Reliability Analysis Update

Transmission Expansion Advisory Committee

October 6, 2026

B4036.17 Scope Change

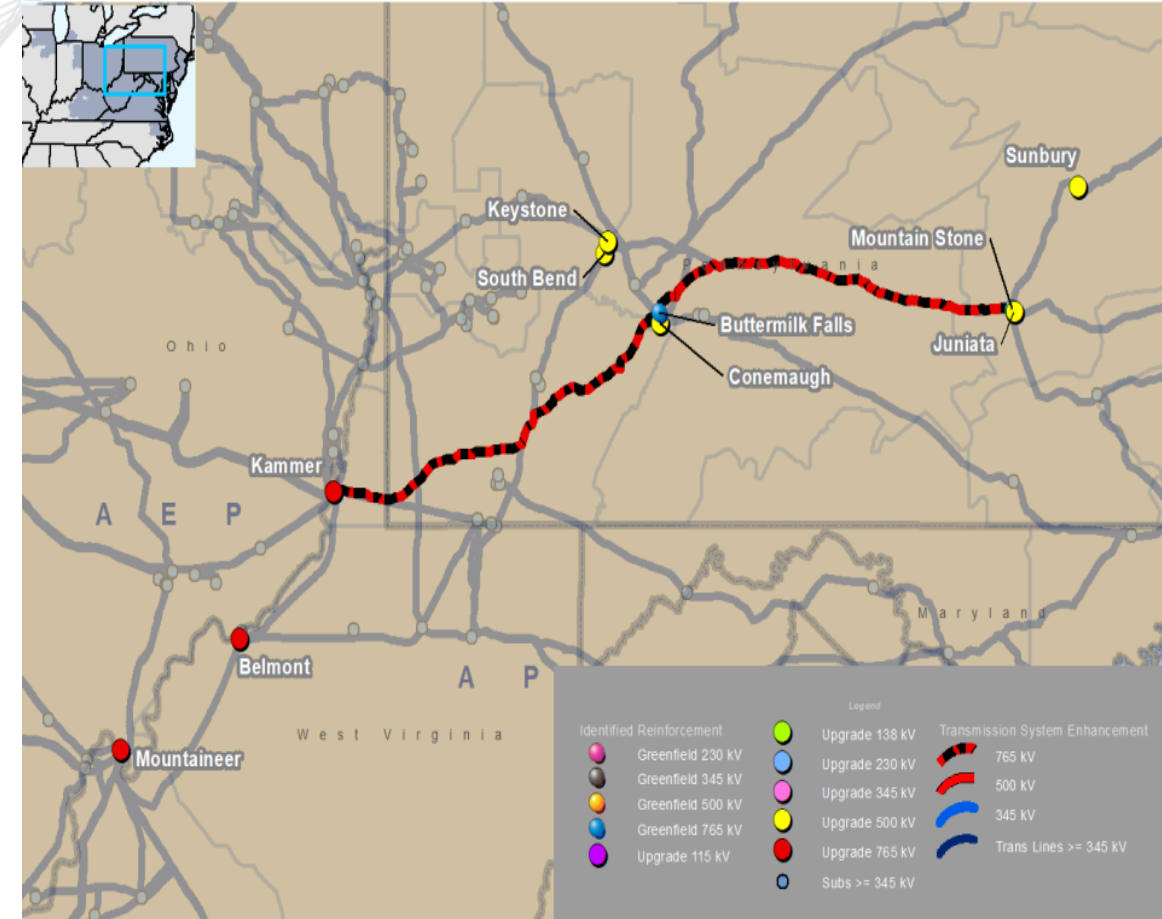
As part of the NextEra approved 2025-W1-237 projects, NextEra submitted a project to reconfigure the Sunbury 500 kV GIS substation. PPL further reviewed the scope and identified additional work is needed

Old Scope : Sunbury - Install two new 500 kV circuit breakers with 63 kA, 5,000 Amps rating in transformer T24 and T25 bay . Both transformers will be in double bus double breaker position after adding these two new breakers.

New Scope: Reconfigure the Sunbury 500 kV substation. Install new 500 kV circuit breaker at bay 4 and move T24 to bay 4 making it breaker and half configuration.

New Estimated Total Cost: \$30M
